RE: Addendum No. **1 (One)** to the Bidding Documents for:
AMHI Potting Shed Conversion, Augusta, ME 04333

This Addendum forms a part of the Contract Documents and modifies the original Bidding Documents dated 12/22/2015. Acknowledge receipt of this Addendum in the space provided on the Proposal Form. Failure to do so may subject Bidder to disqualification.

This Addendum consists of (6) Six pages and (8) Eight drawings & (13) Thirteen Sketches SK's (1) one REVISED Wage Determination Schedule

ADDENDUM #1 CSK-1	REVISIONS TO SITE PLAN	
	AMHI - POTTING SHED CONVERSION FOR BUREAU OF GENERAL SERVICES	
	SCALE: 1" = 10'	PROJ NO:
	DATE: 01/05/2016	CAD FILE:

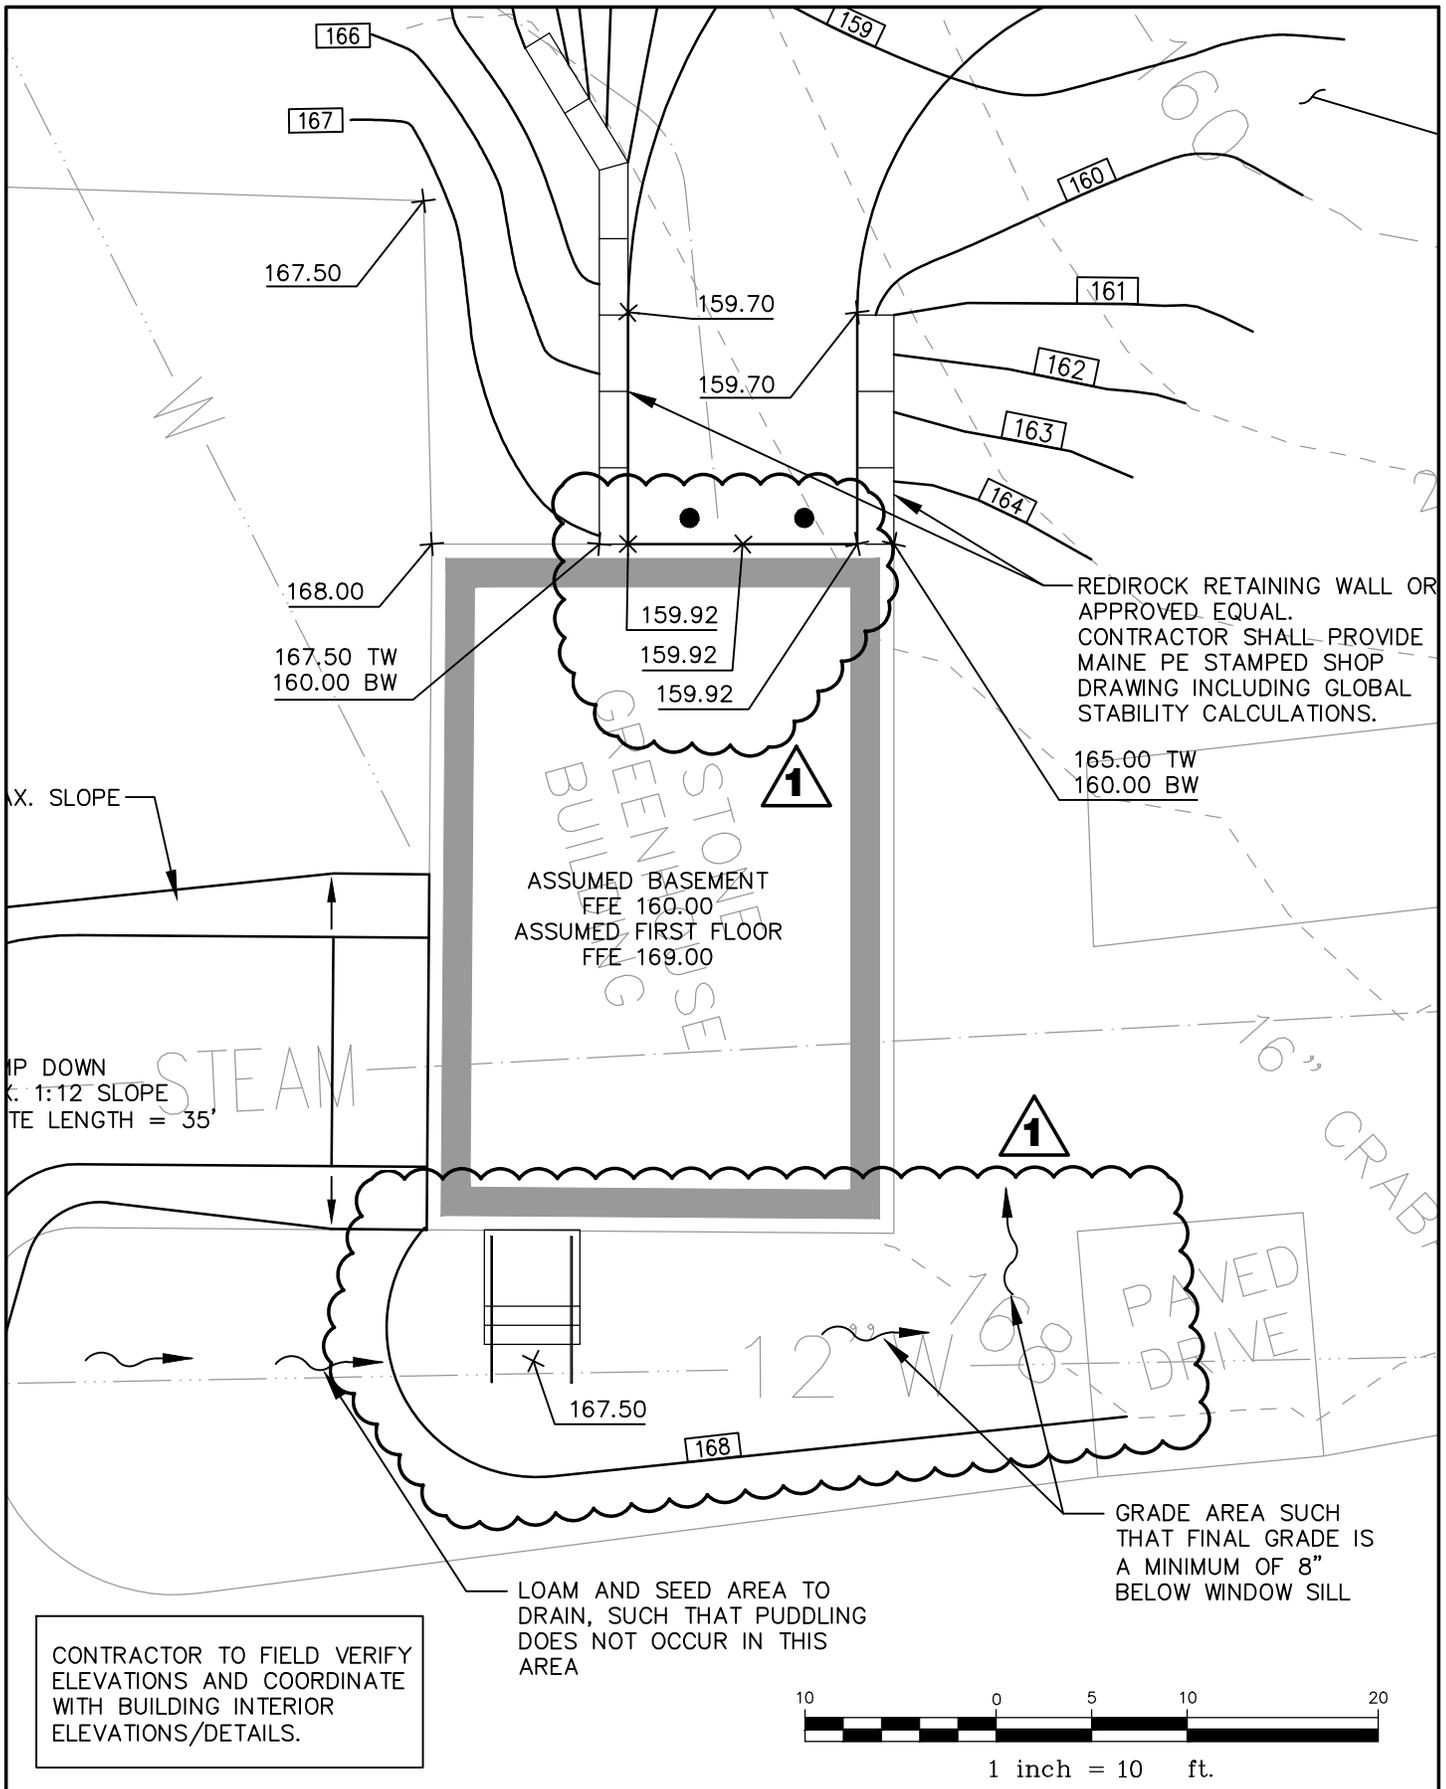
1. **ADD** CSK -1 for modifications to site plan

SKA-01
ADDENDUM #1

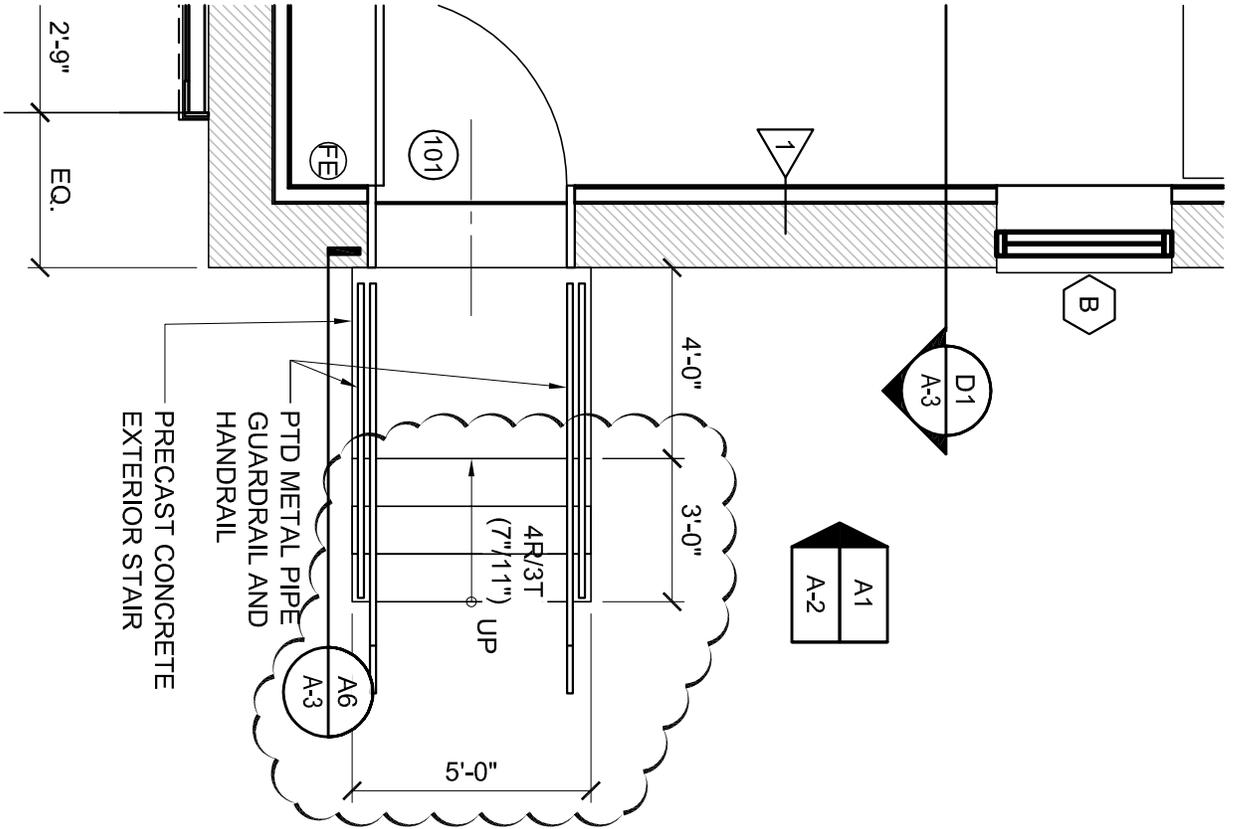
- a. **DELETE** Stair detail in its entirety
- b. **ADD** in its place SKA-01
- c. **DELETE** NOTE “42” HIGH PTD METAL GUARDRAIL AT RAMP WALLS”
- d. **ADD** in its place:
42” HIGH 10 LONG METAL GUARDRAIL ATOP EACH RETAINING, PRIMED AND PAINTED EXTENDING FROM BUILDING WALL

REVISION TO D1/A-1 FIRST FLOOR PLAN (PARTIAL PLAN VIEW)	
AMHI - POTTING SHED CONVERSION FOR BUREAU OF GENERAL SERVICES	
SCALE: 1/4" = 1'-0"	PROJ NO: 15056
DATE: 01/05/2016	CAD FILE: 15056A.dwg

TYPICAL WINDOW HEAD/JAMB/SILL DETAIL

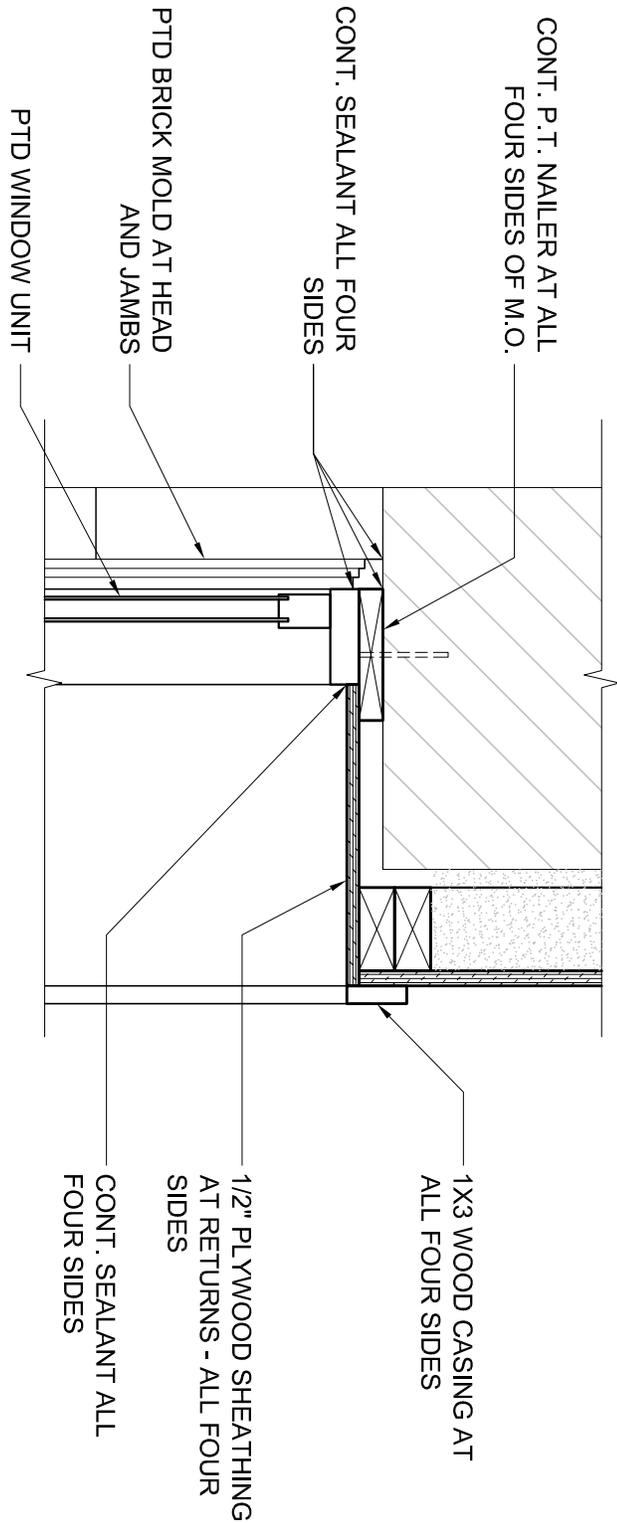
14. ARCHITECTURAL DETAILS
 1. **ADD** SKA-04 Typical window/ Head/jamb detail
 2. **ADD** SKA-05 Overhead door Head Detail at door 001 (basement)
 3. **ADD** SKA-06 Overhead door Jamb Detail at door 001 (basement)
 4. **ADD** SKA-07 Overhead door Head Detail at door 102 (first floor)
 5. **ADD** SKA-08 Overhead door Jamb Detail at door 102 (first floor)
